TRC AGENDA

**CITY OF DELAND
THURSDAY JANUARY 19, 2023 AT 1:30 P.M.
CITY OF DELAND TRC MEETING ROOM
DELAND, FLORIDA**

City of DeLand
TRC
SP22-183
JANUARY 19, 2023

City of DeLand
TRC
SP22-247
JANUARY 19, 2023

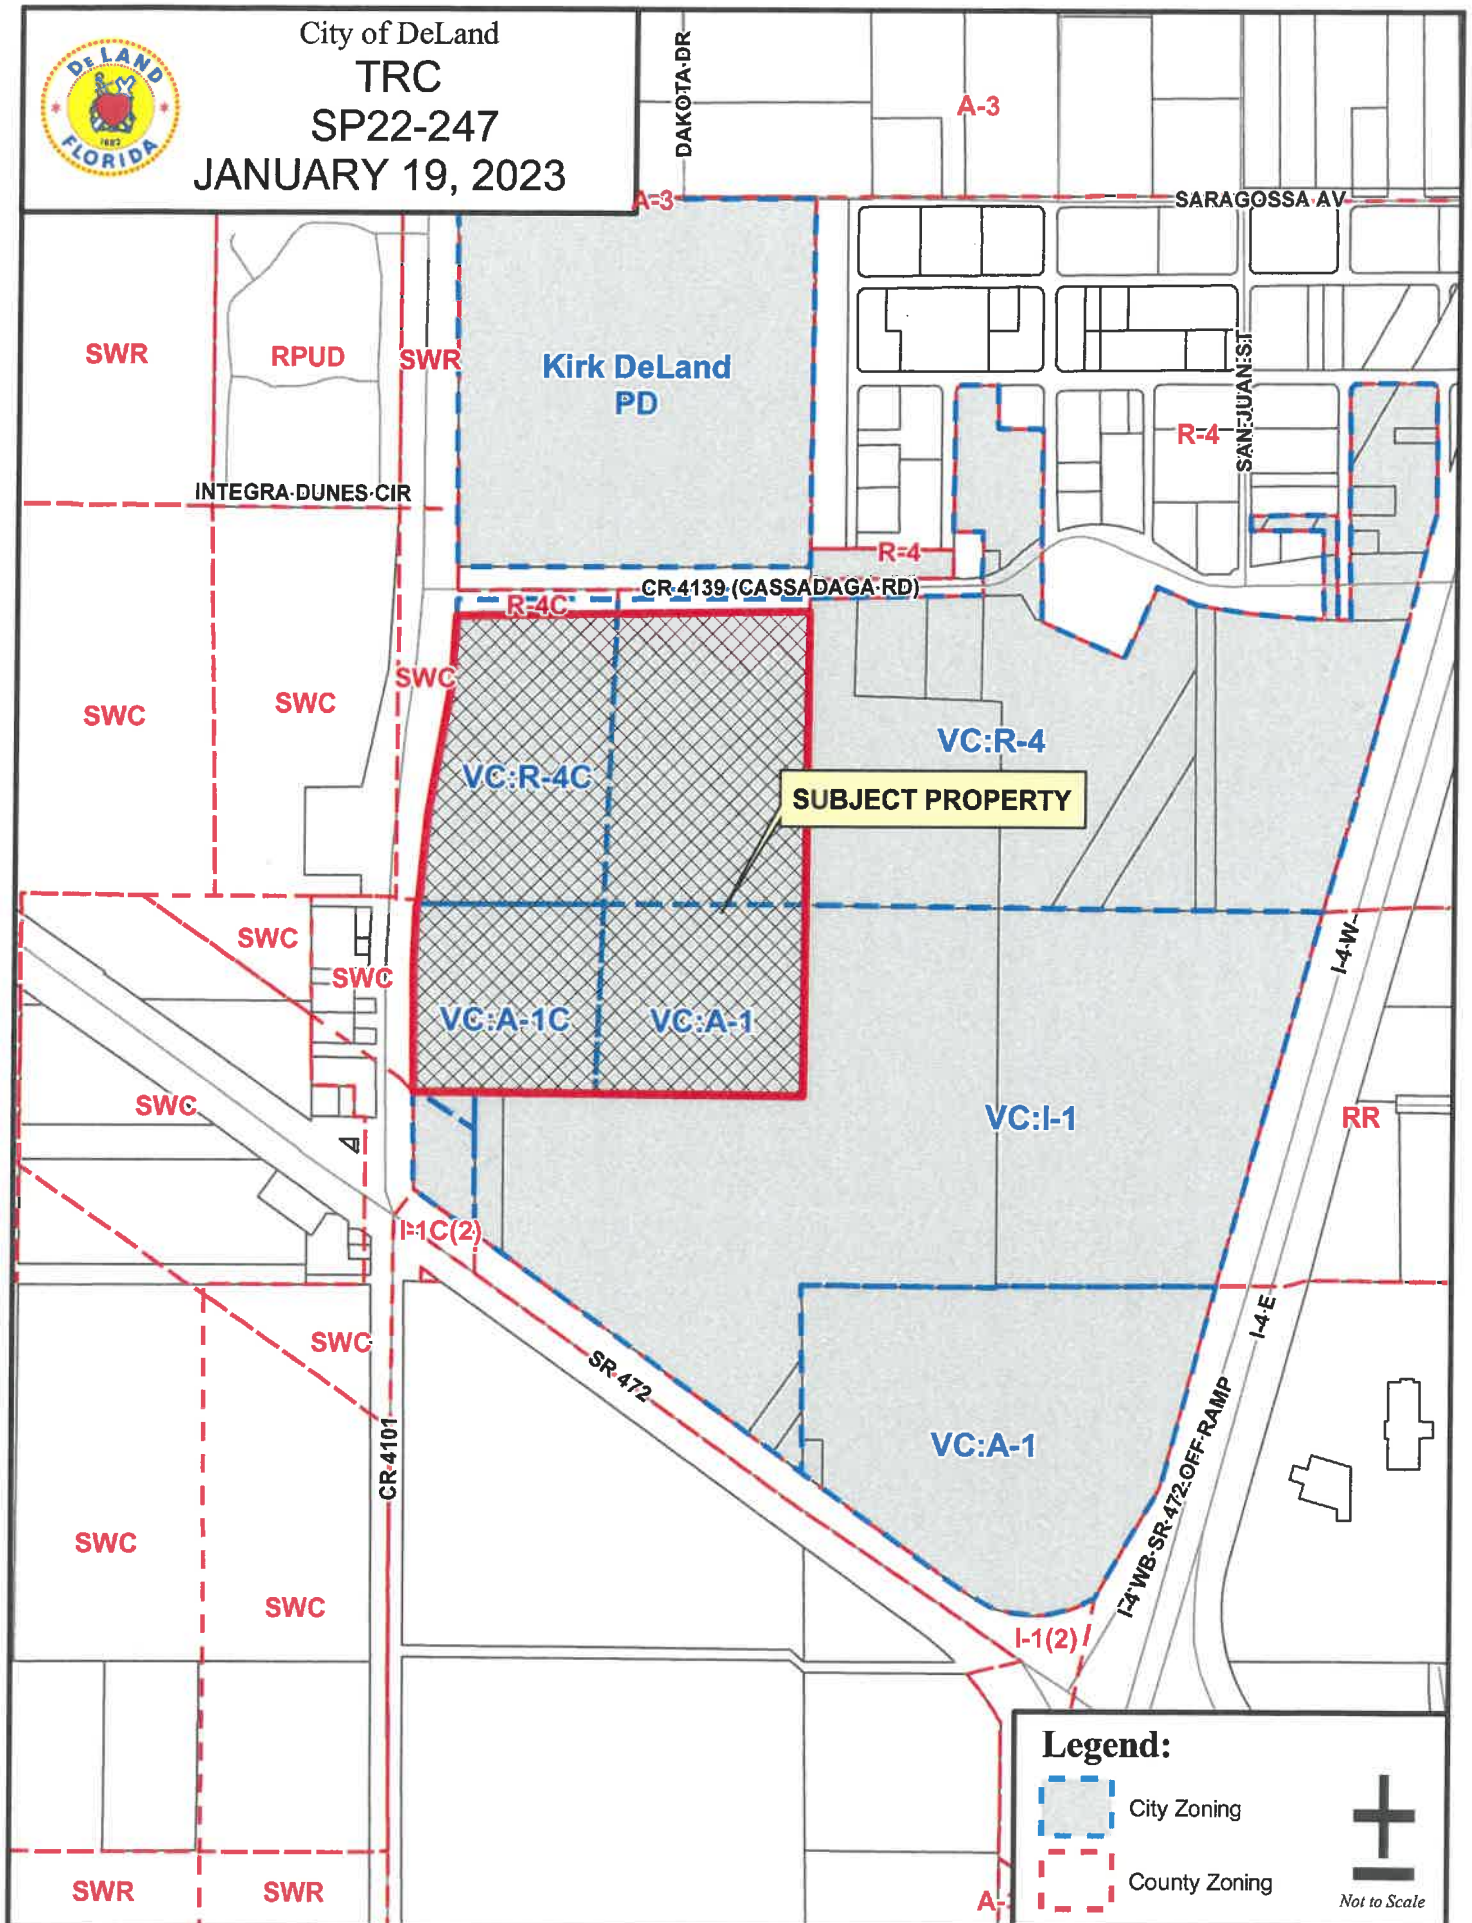
Discipline	Status	Details	Attached To	Created By	Last Updated By	Modifications Required
Engineering	Not Accepted	Drainage Calculations 1. Project narrative, please mention who is the maintenance entity for the proposed stormwater pond and secondary storm sewer system. 2. Project narrative Soils, provide the existing ground elevations at borings P-1 and P-2 in order to verify that the minus 17 feet below ground to SHWT correspond to elevation 20.50 feet used in the ICPR 14 days recovery analysis. 3. Project narrative, please provide a table summarizing the stormwater design results to include Pond 1 design high water (DHW) stage, provide free-board, and post attenuation volume for 25yr-96hr and 100yr-24hr storm events. 4. Pond 1 stage / storage spreadsheet, please include stage/area/cumulative storage at one-foot increments from pond bottom to top elevation (El. 30.0 to 36.00) and do likewise for the ICPR Node Pond 1 input. 5. Per SJRWMD rule, the 25yr-96hr storm volume must recovery within 14 days. But ICPR results show recovery at hour 408.5, which is 17 days. Please clarify. 6. Please provide hydraulic grade line (HGL) calculations for the secondary storm system to verify that the curb and ditch bottom inlets will not surcharge under 10yr-24hr storm event. HGL must be min. 6 inches below the gutter or grate elevations with minor and major losses included. Please use Pond 1 ICPR routed 10yr-24hr storm peak stage as the downstream tailwater elevation for the storm sewer HGL analysis.		Tuan Huynh	Tuan Huynh	Yes

1. HGL spreadsheet calculations used Pond 1 tailwater elevation 31.58 feet (10yr-24hr storm DHW). However, ICPR Post Node Max results show the Pond 10yr-24hr peak stage of 33.17 feet. This should be the initial tailwater for the storm sewer HGL analysis. Please check HGL analysis and re-submit drainage calculations and revise grading plans (inlets and pipes) if needed.

Last comment from reviewer: Historic trees are replaced at 100% DBH, not 3:1.

Forestry	Not Accepted	Last comment from reviewer: Please double check your tree replacement calculations. My calculations indicate that you will need 3,556" DBH replacement, and your plan would provide 1208" DBH if the Grape Myrtles are counted at 3" DBH instead of the 3" caliper that you stated in the comments. This would leave you 2,348" DBH deficient and require either additional landscaping or a contribution of \$176,100 into the Tree Replacement Reserve Account	L7.0	Mariellen Calabro	Mariellen Calabro	Yes
Last response: Tree removal plan and tables revised to reflect correct counts and replacement ratios.						
Grape Myrtle						
The minimum size for replacement trees is 3" caliper, 8' height, and 45-gallon container or B& B equivalent. Please increase the trees proposed to meet these standards.						
Forestry	Not Accepted	Last comment from reviewer: Tree was increased to 3" DBH, but the height and container size (root ball) has not been adjusted.	L7.0	Mariellen Calabro	Mariellen Calabro	Yes

1. TPA: Please show limits of TPA clearly on plan.				
		2. Minimum Coverage: 2,994" DBH will be required. I cannot determine whether this requirement will be met without more data on trees removed and preserved.

1. Show existing 12-inch diameter water main along Cassadaga Road that was installed recently as part of the Canopy Terrace improvements.
2. Sheet C8.3: The 8" water main stub to Cassadaga does not exist. Show a wet tap onto the existing 12-inch diameter water main along Cassadaga Road.

3. Sheet C8.10: Relocate the master potable water meter to the stub-out located in the Dr. Martin Luther King Jr Beltway (MLK) right-of-way.
4. For each potable master meter, specify an F2 meter with strainer and reduced pressure check valve.

7. For each reuse master meter, specify a Sensus C-2 meter and remove the backflow from the assembly.
8. For each reuse connection tap, specify a stainless steel tapping sleeve and valve.

Last response: 1. Project narrative of the stormwater report has been updated to state that the maintenance entity for the proposed stormwater pond and secondary storm sewer will be the owner/developer.
 2. Borings P-1 and P-2 are now shown on the Paving, Grading, and Drainage Plan Sheet C6.7 with existing elevations shown as 37.5 and 36.1 respectively. Boring P-1 did not encounter groundwater up to 20' below the existing surface, and boring P-2 encountered

Discipline	Status	Details	Attached To	Created By	Last Updated By	Modifications Required
Last response: Notes revised to match DeLand code. Please see sheet L 7.0.						
Tree Legend						
The tree legend on this page does not match what is shown on previous pages.						
Forestry	Not Accepted	Last comment from reviewer: Do you need this legend here? I don't think that it matches your tree survey	L7.0	Mariellen Calabro	Mariellen Calabro	Yes
Last response: Tree legend updated to match symbols and quantities from planting plan. Please see sheet L 7.0.						
Tree Replacement Provided						
With the recommended changes, your plan would provide 1,086" DBH replacement. Your Tree Removal Schedule indicates that you need at last 5,422" DBH (more data is needed to verify this number). This would leave you 4,336" DBH short of the required tree replacement. You will need to add additional landscaping or contribute the difference into the Tree Replacement Reserve Account. At the current rate of \$75 per inch DBH not planted, this would require a contribution of \$325,200.

Last response: Tree sizes increased to 3" caliper.						
City of DeLand Irrigation Notes						
Forestry	Not Accepted	Provide zones, watering schedule and other items in this list.	L6.0	Mariellen Calabro	Mariellen Calabro	Yes
Last response: Information on zones and schedule added to irrigation details sheet.

City of DeLand
TRC
SP22-249
JANUARY 19, 2022

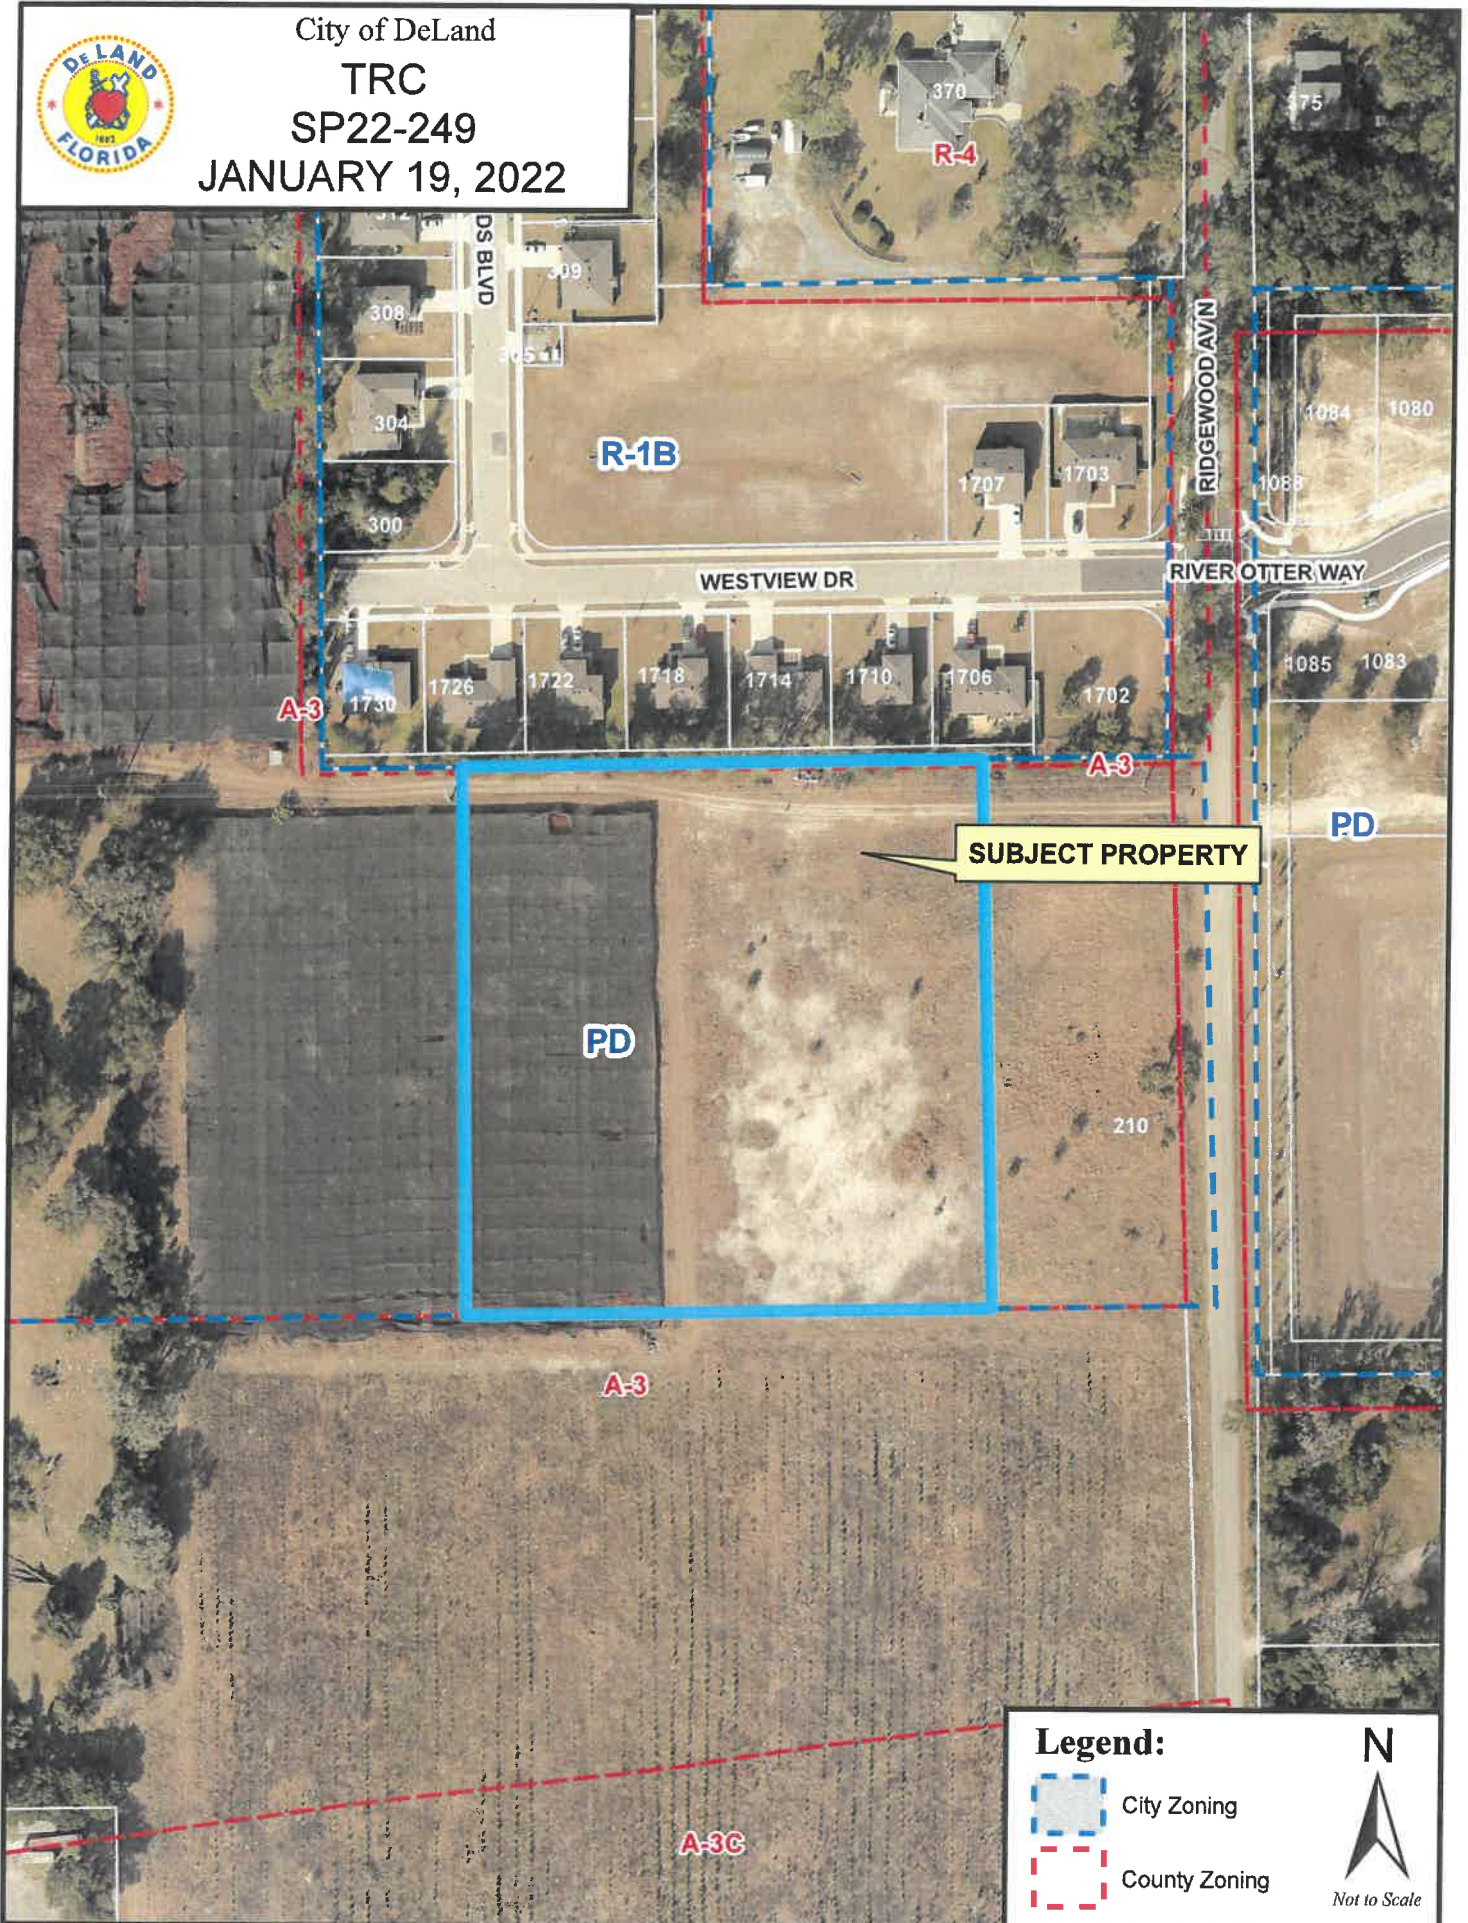
Discipline	Status	Details	Attached To	Created By	Last Updated By	Modifications Required
Building	Draft	parking 1. Will need handicap space provided at existing parking in front of pocket park.		Larry Hites	Larry Hites	Yes
Engineering	Draft	Sidewalk ADA path and existing fire hydrant 1. Existing fire hydrant is shown very close to detectable warning surface at the proposed driveway. Please check to ensure that min. 4 feet wide ADA clearance is provided along the sidewalk path.	C-1.0	Tuan Huynh	Tuan Huynh	Yes
Engineering	Draft	Parking lot striping 1. Show 20 LF of double yellow lines, 24" white stop bar, and stop sign (R1-1) at the parking lot entrance. Note on the plan striping per FDOT Standard Plans Index 711-001. 2. Callout striping for the parking and handicap spaces per FDOT Standard Plans Index 711-001.	C-1.0	Tuan Huynh	Tuan Huynh	Yes
Engineering	Draft	ADA slopes 1. Provide additional spot grades on north side of handicap parking space (at all four corners) to ensure that the slopes do not exceed 2% in all directions per ADA. 2. Please add a note that sidewalk portions across the new driveway cross-slopes must not exceed 2% per ADA.	C-1.0	Tuan Huynh	Tuan Huynh	Yes

Engineering	Draft	Parking lot positive drainage 1. Show the nearest street curb inlet with EOP/gutter elevation to ensure that runoff from the proposed parking lot has positive drainage flow to the inlet.	C-1.0	Tuan Huynh	Tuan Huynh	Yes
Forestry	Draft	Lot 10 Lot 10 will need to meet requirements of overall subdivision site plan upon construction of single-family residence at this location.	LS-01	Mariellen Calabro	Mariellen Calabro	No
Forestry	Draft	11 B I'm not sure what this section references. There is no need to prune to stimulate root growth.	ID-01	Mariellen Calabro	Mariellen Calabro	Yes

Discipline	Status	Details	Attached To	Created By	Last Updated By	Modifications Required
ML						
Forestry	Draft	100-gallon container size is large for a 3" to 4" caliper tree. Revise specifications so that the container size matches the caliper.	LS-01	Mariellen Calabro	Mariellen Calabro	Yes
LM, PD 2, & QV						
Forestry	Draft	Revise specifications to match Florida Grades and Standards. Minimum height should be reduced to 8' height with a 4' spread.	LS-01	Mariellen Calabro	Mariellen Calabro	Yes
IE						
Forestry	Draft	Reduce minimum height for IE from 12' - 14' to 8' to match Florida Grades and Standards and the City of DeLand minimum tree size specifications.	LS-01	Mariellen Calabro	Mariellen Calabro	Yes
General Comments						
Planning	Draft	1. Verify which of the lots is the location of the sales office. 2. Verify the number of employee parking spaces and provide an explanation of where sales employees will park. Driveways and garages may be suitable parking space to avoid use of spaces required for customers. 3. Provide temporary striping across the street to connect the models. 4. The sales office may operate between the hours of 9 am – 9 pm each day.
